Statement of Response to LRD Opinion

Ref. PAC/LRD2/004/23

**at
Glenageary Gate,
Co. Dublin**

Red Rock Glenageary Ltd.

Figure 4 – Layout Plan and Sections showing relationship between basement ramp and ground floor units

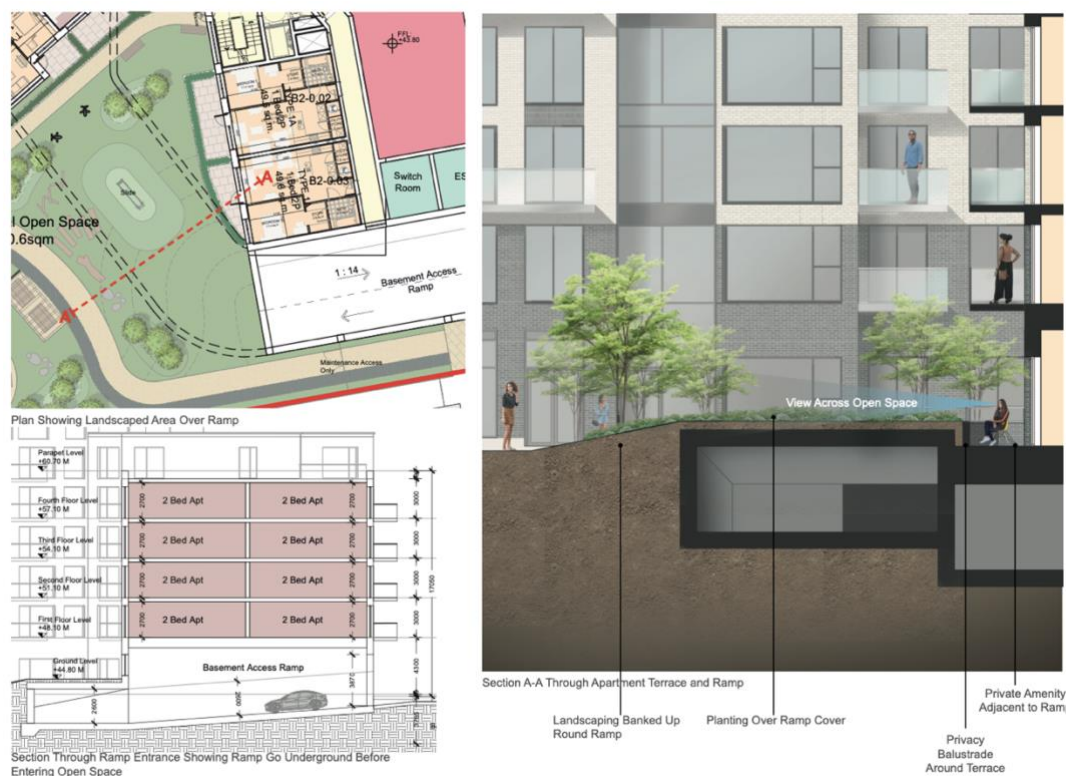
“Insufficient evidence has been provided to demonstrate that the proposed development will be able to provide a high level of residential amenity/privacy for future residents on the ground floor level adjacent to the basement parking ramp and the applicant should minimise any impacts on the residential amenity of future occupants of these units from the underground carpark access. A full Daylight and Sunlight Analysis should be submitted also. The Applicant is requested to reconsider the level of amenity afforded

In response to this Item, the Design Team has revised the ramp to the basement level to be fully covered and integrated into the landscaping of the communal open space to minimise any impacts on the residential amenity of future residents and particularly any impacts on the ground floor level residential units. The ramp has been amended to ensure it does not protrude above ground level and will not interrupt views from the adjoining terraces across the landscaped communal amenity space, nor will it have a shading impact on the apartments or their amenity. At its height, the ramp's protrusion above ground level will be no higher than a typical privacy balustrade around the ground floor apartment terraces and in this way, there will be minimal effect on the amenity of the adjoining apartments as evidenced in the Figure below. A specific response to this Item has also been prepared by John Fleming Architects and is detailed in Section 3 of the accompanying Architectural Design Statement.

Figure 6 – Block B2 Roof Terrace Access Diagram

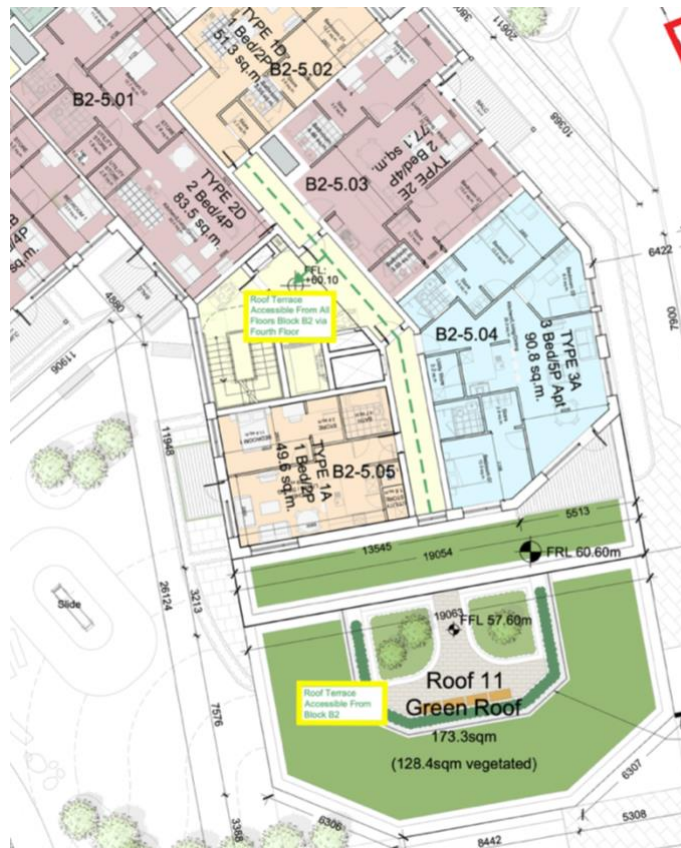
“Insufficient evidence has been provided to demonstrate that the proposed development is in accordance with the quantitative and qualitative standards for public and communal open space set out by the Dun Laoghaire-Rathdown County Development Plan, 2022-2028. This is particularly in terms of the high level of hard landscaping around the site, including the perimeter and streetscape facing boundaries and public facing/ shared areas e.g. planters (tress along northwest of Block A on Sallynoggin Road considered essential). There is a lack of detailing regarding any informal seating, and separation between blocks with regard to potential shadowing on amenity spaces and also consideration of overshadowing on planting plans, details regards the usability of communal open space, and access from Block A to Communal space, and Core should more easily connect to 5th floor roof garden regards only partial access from Block B, and boundary treatments softening of the pedestrian walkway. Lack of detailing regarding SuDS pits that may be blocked by tree planting (tree pits should be incorporated into SuDS scheme), and northeast watermain that may be a constraint and may restrict larger trees, noting potential surface water sewer relocation (which may also allow for larger trees and good proportion to buildings). Lack of detailing regarding Taking-in-Charge (TIC) if any and clear delineation, and boundary treatments to Lidl side of site, and Universal access map required. Also lack of details regards any resident's access to creche play area within the Communal open space and management and periods of access (weekdays/ weekends), etc. of said access.”

Block B surrounds and encloses the south facing communal open space (c. 750.6 sqm) which will be exclusive to the residents of the scheme and has comprehensive landscaping proposals are included for the proposed development including a range of facilities for children of different ages, parents and the elderly. Residential communal open space is also proposed in the form of 2 no. roof gardens at link between Block A and Block B and at fifth floor level of Block B equating to c. 207.6 sqm. All future residents of the scheme will have access to a roof terrace. In direct response to this LRD Opinion Item, a roof terrace was introduced at fourth floor level of Block B1 which has a separate core to Blocks A and B1. Access to this roof terrace is available for all future residents of Block B2 from all floor levels by lift or stairs.

Figure 11 – Proposed Bicycle Shelter Design

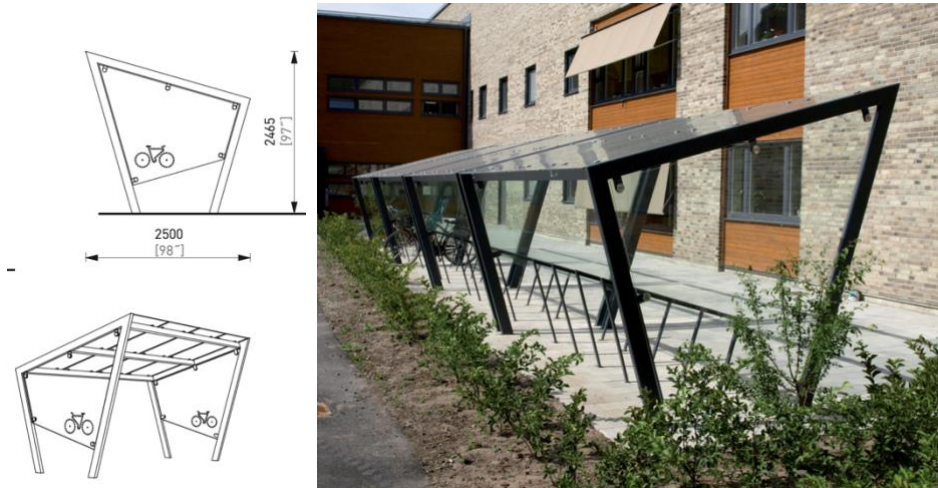
- c) Cycle parking: Compliance with Standards for Cycle Parking and associated Cycling Facilities for New Developments – January 2018'. The Applicant is requested to provide quality designed surface level cycle parking within the proposed development with a level of covered cycle parking also provided. A segregated basement ramp from cycle parking, as well as a lift to the proposed basement cycle parking area should be provided for cyclists.**

In accordance with DLRCC's standards, we confirm that a minimum of 50% of the total surface level / short-term bicycle parking spaces are to be covered by way of the proposed bicycle shelters detailed in the Landscape Design Statement prepared by Parkhood Landscape Architects and by the link between Block A and Block B. It is considered that the bicycle shelter design proposed is visually appealing through a dynamic shape combining a robust support structure and visually light glass.

Figure 12 – Proposed Pedestrian Crossings on Glenageary Avenue

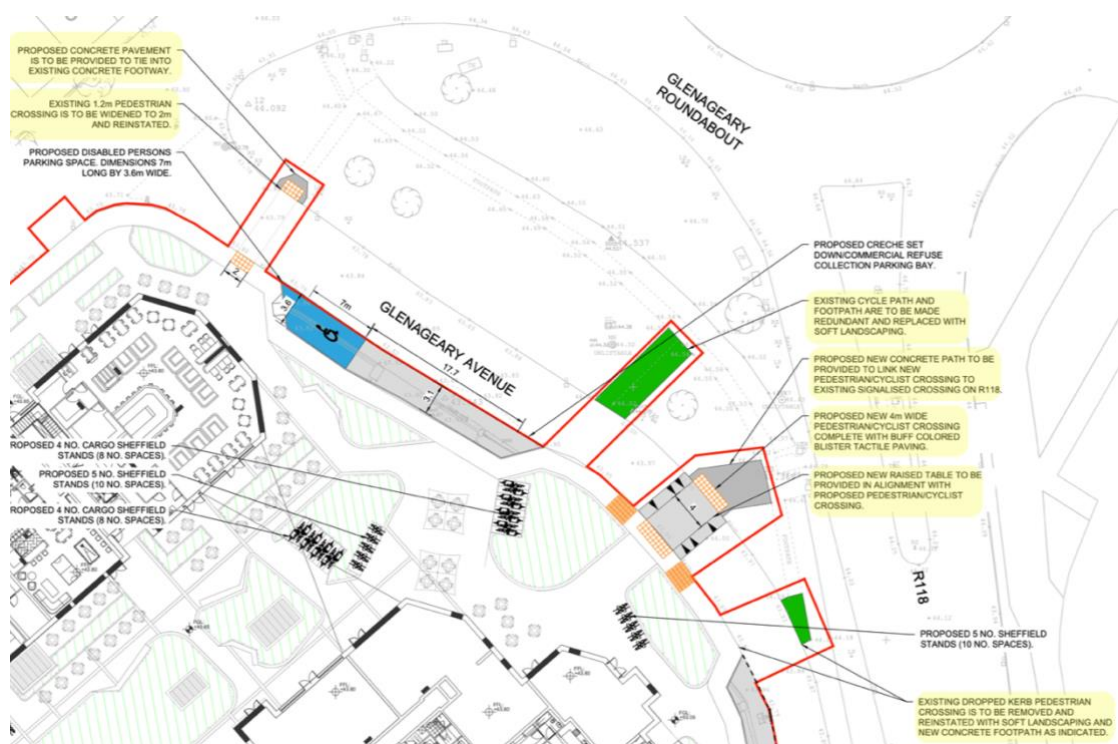
- i) ***Applicant should liaise with the Planning Authority to agree all proposed and required works to the public realm in the vicinity of the site - including works to improve pedestrian and cyclists connectivity (and details to include drawings which demonstrate the agreed changes shall be included as part of any final application), and (notwithstanding submitted MMP) that the submitted Mobility Management Plan (MMP) should be updated to demonstrate measures, targets and recommendations for the proposed childcare facility/creche, and for revised details for a Standalone Construction Management Plan to deal with traffic conflicts etc, (and the submitted TIA also noted).***

AECOM Consulting Engineers have directly liaised with the DLRCC Transport Planning Department in relation to the Item above and the following has been agreed in principle:

- A new raised table, complete with a 4m wide uncontrolled shared pedestrian / cyclist crossing, has been proposed on Glenageary Avenue, matching the desire line as requested.
- The existing pedestrian crossing on Glenageary Avenue, at the junction between Glenageary Avenue and Sallynoggin Road, is proposed to be increased in width from 1.2m wide to 2m wide.

Recessed Balconies Elevation

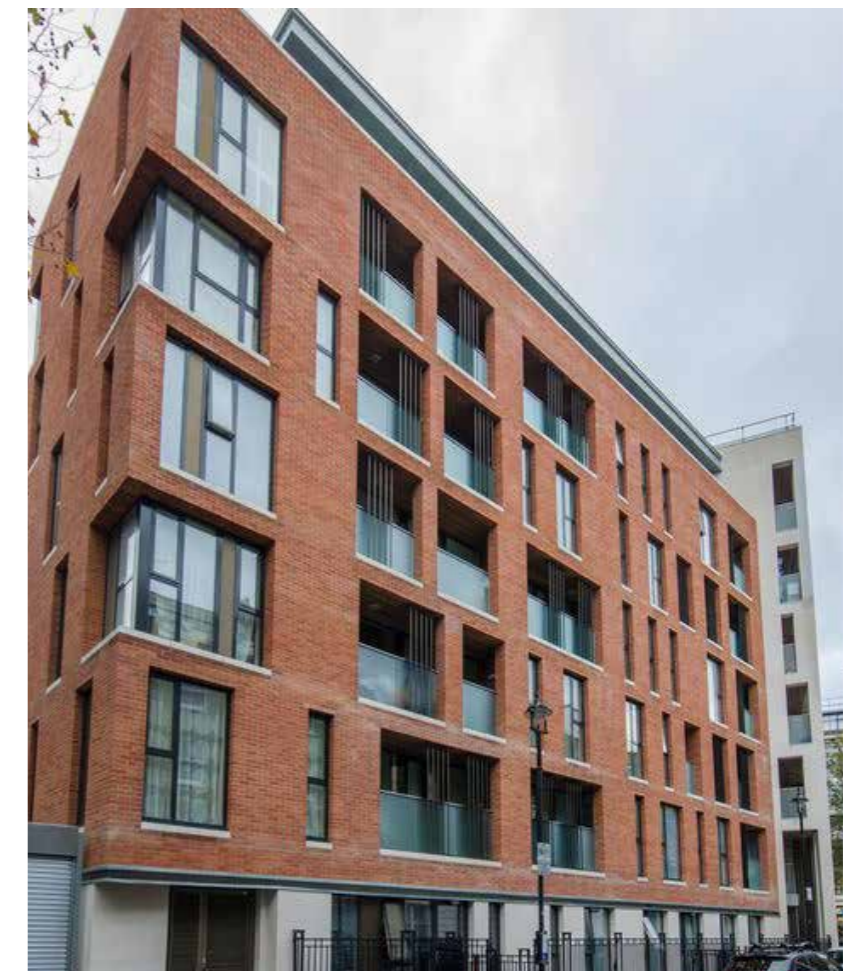
“The Planning Authority have concerns regarding the design and form of the proposed balconies, which read as ‘add-ons’ to the proposed blocks. The applicant is advised to modify the design so that the balconies read as part of and integral to the proposed building structure, by providing recessed balconies or similar which would result in a high quality design and provide a high level of amenity for future residents. The Applicant is requested to also consider the visual impact of the proposed balconies, as viewed from the public realm, when in use by residents and submit proposals for balcony screening (enclosing balconies or screening materials) which ensure that the use of balconies in the long term does not result in an adverse visual impact when viewed from the public realm.”

From the outset, the brief for this project has been to provide lively active facades that encourage interaction with the street. Recessed balconies would fail to achieve this goal.

Furthermore, on technical grounds recessed balconies carry with them considerable disadvantages both structurally and environmentally, and are at much greater risk of long-term flaws and defects. The primary disadvantage is that the floor slabs for the apartment, must drop approximately 300mm as it exits the envelope of the building. This is because Part M of the building regulations requires level access from the apartment out onto the balcony. To achieve this requirement, the slab must be dropped, with complex detailing of damp proof membranes, firestopping and insulation, all of which are at risk of long-term failure and latent defects.

From the technical drawings on the next page, you will appreciate that the need to drop the slab substantially reduces head height on the balcony below (by at least 300mm/1ft).
